OFFICE OF SURFACE MINING RECLAMATION AND ENFORCEMENT

***Evaluation for Targe Energy dba Coal Valley, LLC
SMA Permit No. O-2005-10, NPDES WV1023721, and UIC 0284-00-033***

April 21, 2011

Harrison County, West Virginia

Figure 5. Location of Permit O-2005-10, Injection site UIC 201, M & J Coal mining and portal area with portal elevations.

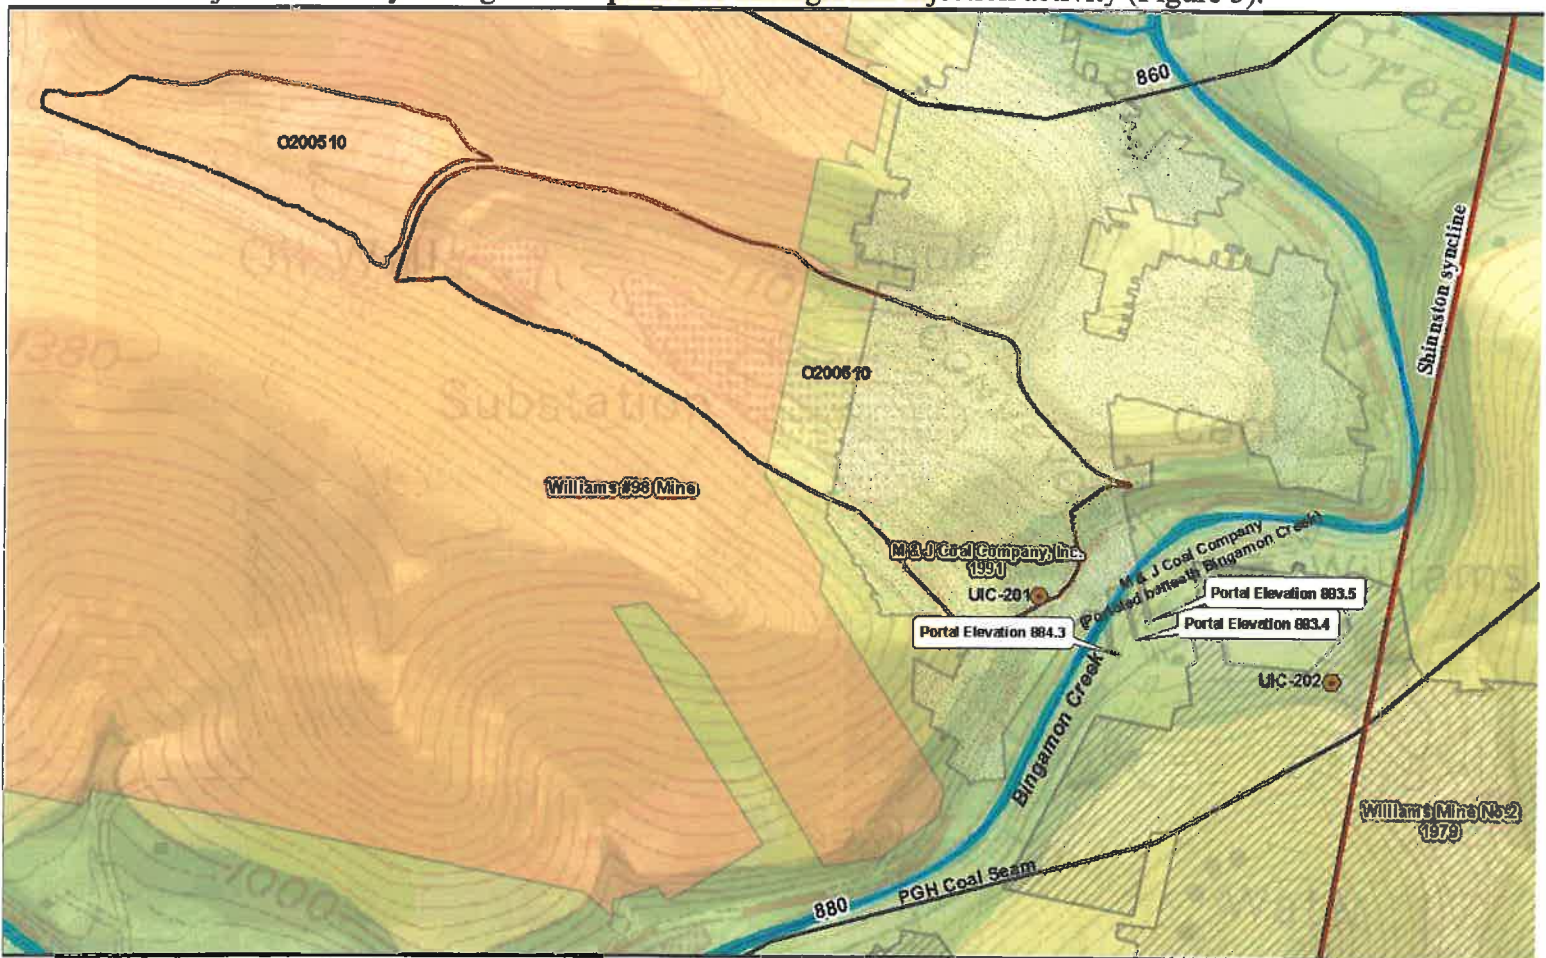
A post SMCRA underground mine (M & J Coal Company, Inc. Permit Number U-1037-86 is located adjacent to the Consol Williams #98 mine. Additionally, the M & J permit is located directly below the Williams No.2 Slurry Impoundment. The M & J permit allowed room and pillar and included second mining. The permit was final released on July 21, 1998. According to the UIC 201 permit it was drilled to a depth of approximately 40 feet and presumably isolated from the Williams #98 Consol deep mine. According to conditions in the UIC permit, the mine pool elevation for UIC 201 was to be maintained at a maximum elevation of 888 feet. This level is to be monitored at least monthly and maintained or reduced through pumping or by cessation of injection activity throughout the period of underground injection activity (Figure 5).

Figure 6. Map for M & J Coal Company, NPDES permit renewal WV1002490 dated 10/20/97, indicating the Williams #98 old mining complex is flooded.

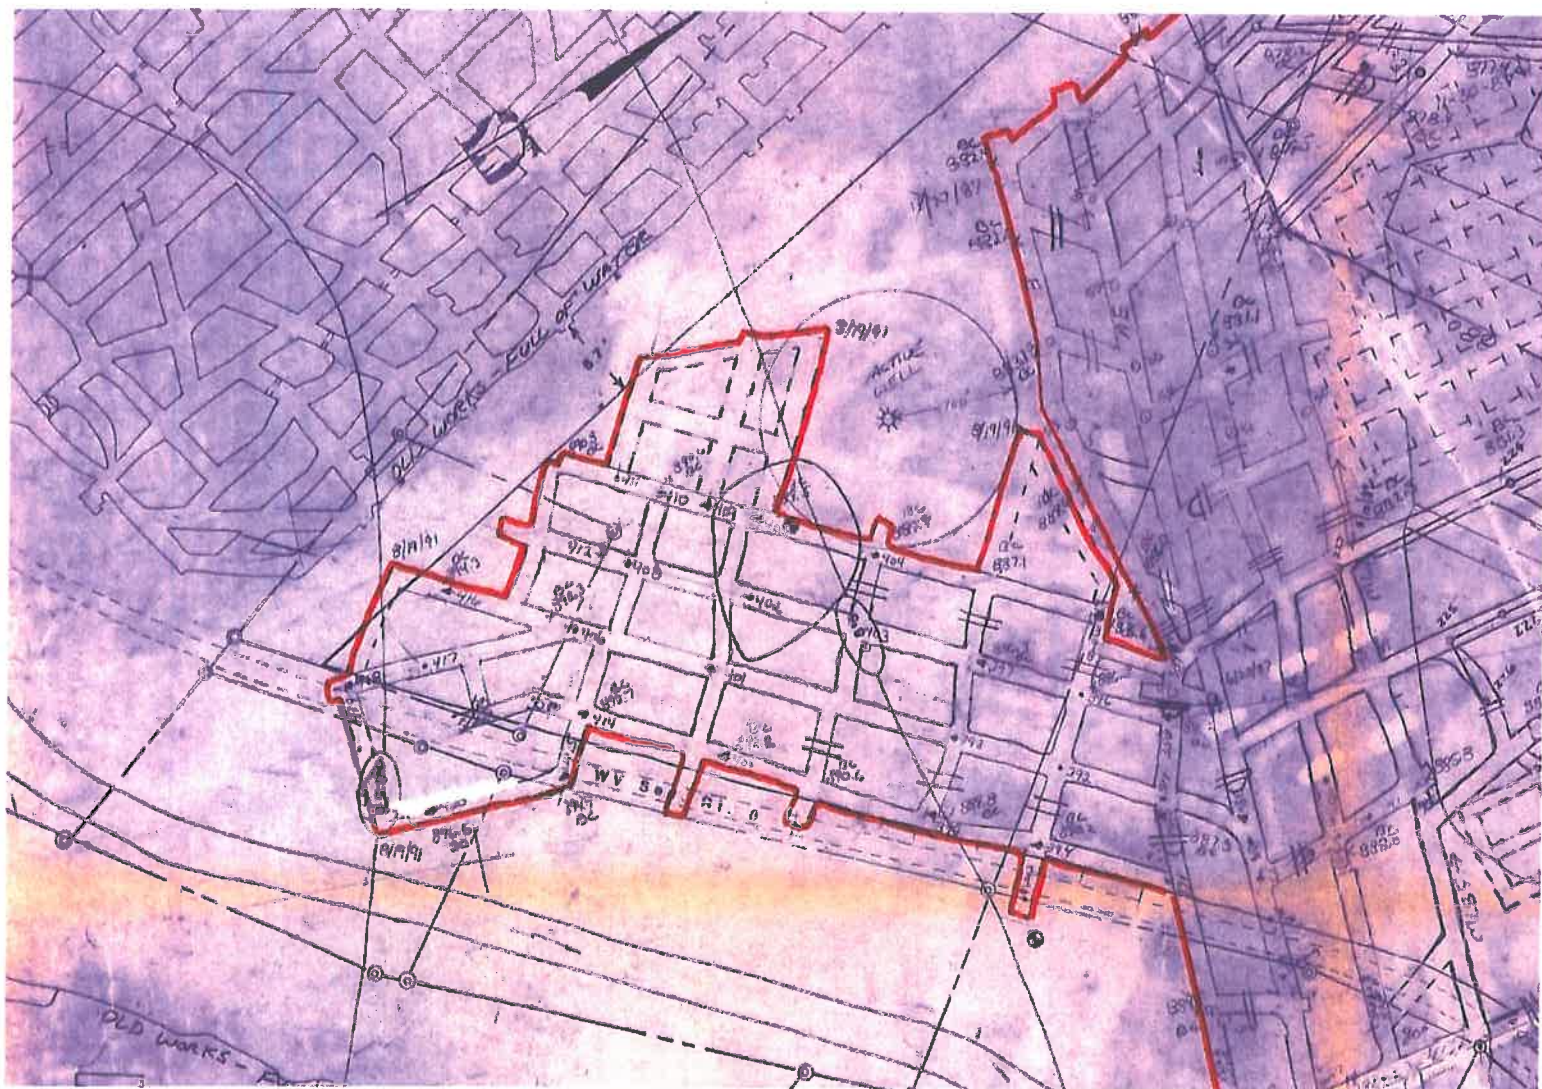
However, even if the slurry were to be injected underground within the impoundment area the runoff and seepage from the toe at the base of the impoundment would not be captured and would continue to discharge to a high quality stream. Additional work is being done to create an elevation map to determine all of the potential upwelling locations and discharges to Bingamon Creek of West Fork base on the final water levels discussed within NPDES permit WV1002490.

Figure 7. Design from Coal Valley, LLC permit.

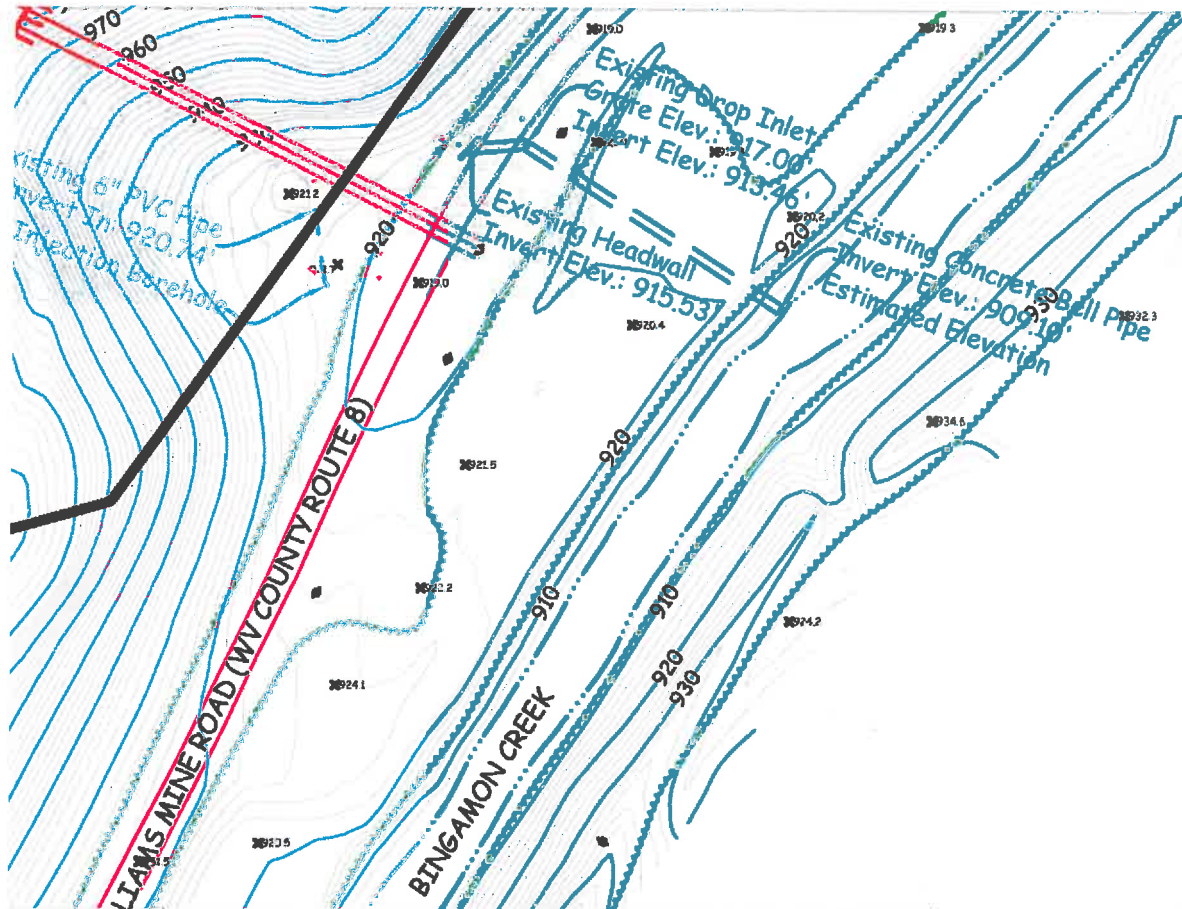
It was determined in the field review that the M & J mine is in fact not restricted and upwells to the surface as well as discharges into Bingamon Creek by entering an inverted drop inlet, (elevation 913.46) that crosses under County Route 8 and discharges through an existing inverted

concrete "Bell Pipe" at an elevation of 909.10 ft. This condition is causing the stream to be stained as a result of precipitates. Water samples were collected by WVDEP from the discharge to Bingamon Creek on March 8, 2011, and results are pending (Figure 7, 8, and 9).

Figure 15. Schematic of upwelling and seeps.

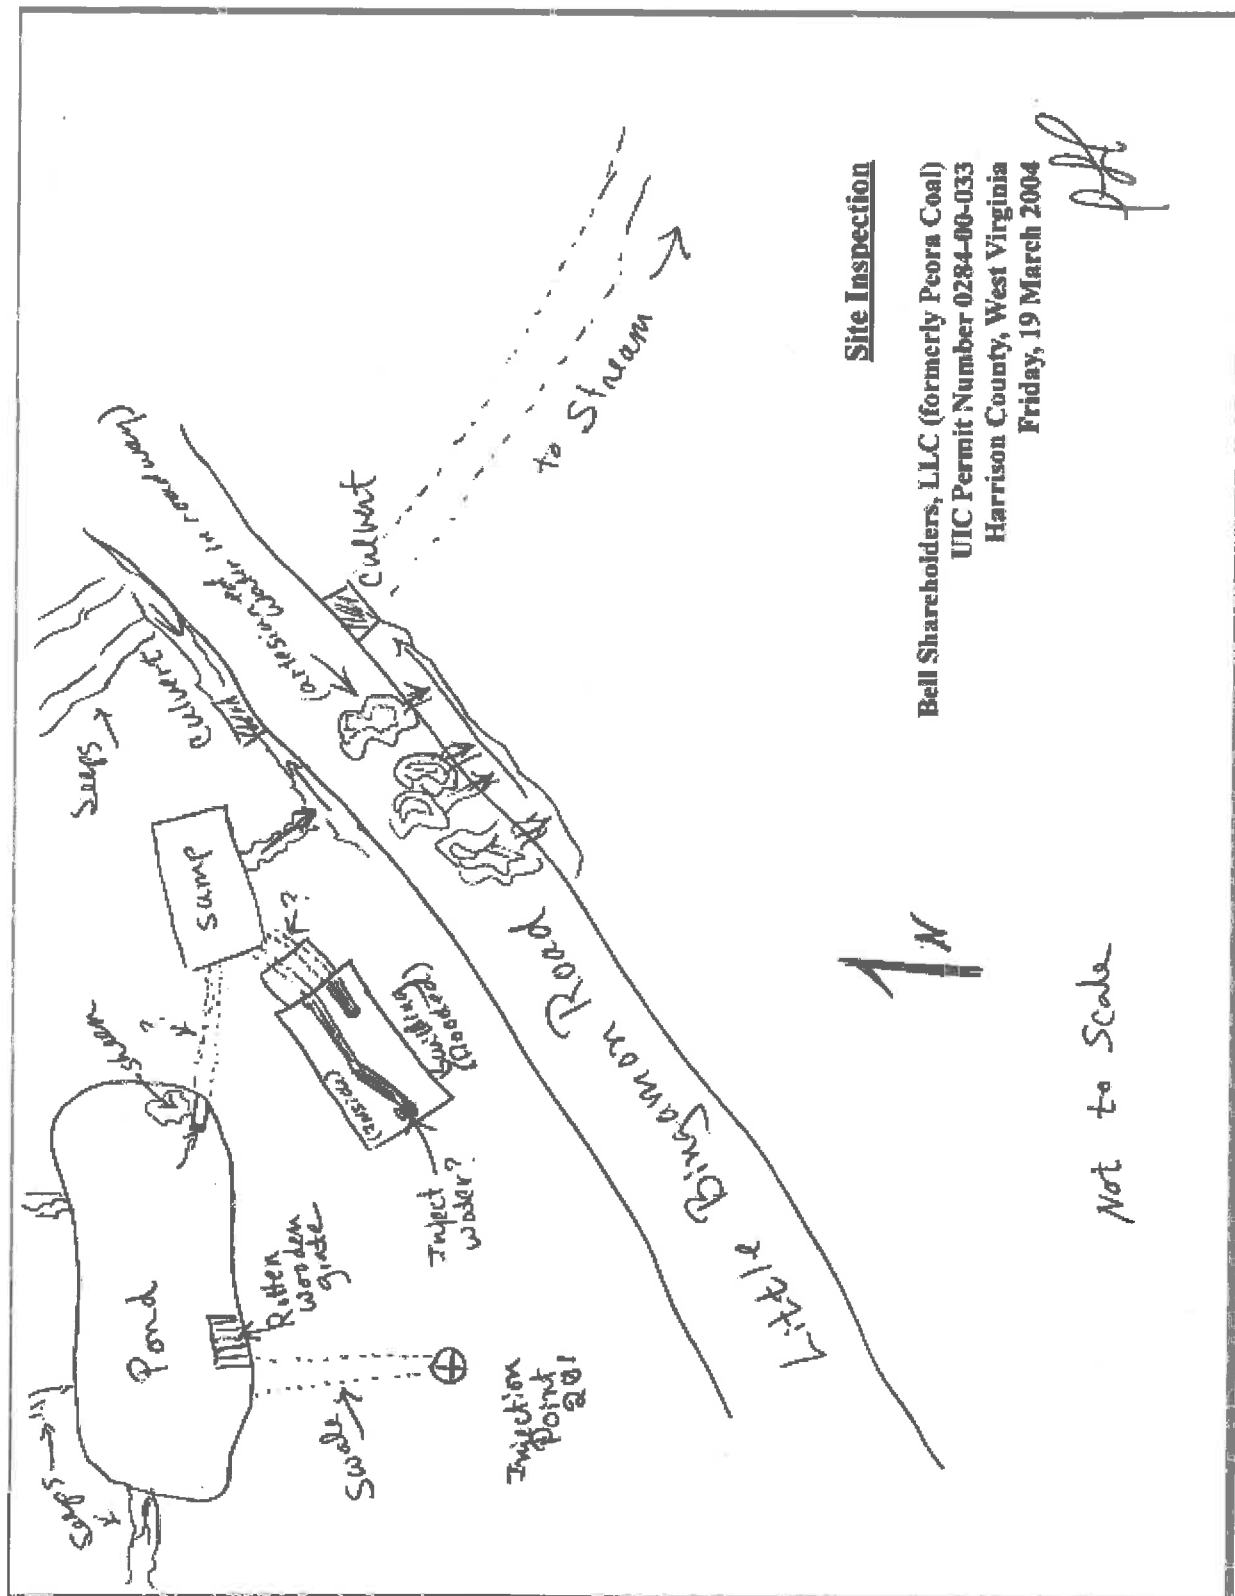
The historical mining by M & J Coal Company, Inc., Permit U-1037-86 where the injection site was installed has a history of seeps, upwelling, and subsidence. Photos from a site visit made on March 19, 2004, by WVDEP in response from a citizen complaint reveal the post mining damage to County Road 8. The subsidence fractures allowed for additional surface infiltration from storm events to infiltrate into an already flooded mine (Figures 13, 14 and 15).

This is an excerpt of conclusions from the March 19, 2004, site visit (Figure 15).
